Technical Service Bulletin

69 Airbag warning light on, DTC B120E1B

69 23 02 2072023/1 November 15, 2023.

Model(s)	Year	VIN Range	Vehicle-Specific Equipment
Q5, Q5 e quattro, Q5 Sportback, SQ5, SQ5 Sportback	2021 – 2024	All	Not Applicable

Figure 1. Tension on connector for airbag release valve igniter.

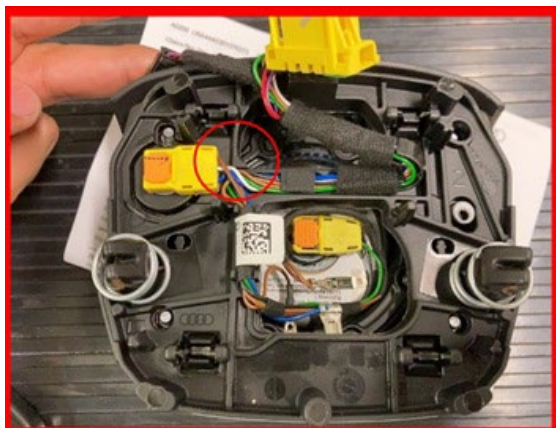
The wire routing of the driver airbag release valve igniter, N490, is not optimal causing tension on the release valve igniter connector. During vibrations, this tension leads to an increased electrical resistance.

1.	Remove the driver airbag according to: <i>Elsa>>Repair manual>>Body>>Body Interior>>69 Passenger Protection, Airbags, Seat Belts>>Driver Side Airbag>>Airbag Unit with Igniter, Removing and Installing.</i>
2.	Check the routing of the driver airbag wire harness. Pay close attention to the wire routing of the driver airbag release valve igniter, N490 (Figure 1, 2).

3. Replace the driver airbag wire harness. Route the new wire harness without causing tension on the airbag connectors.
4. After reinstalling the driver airbag, clear all fault codes.
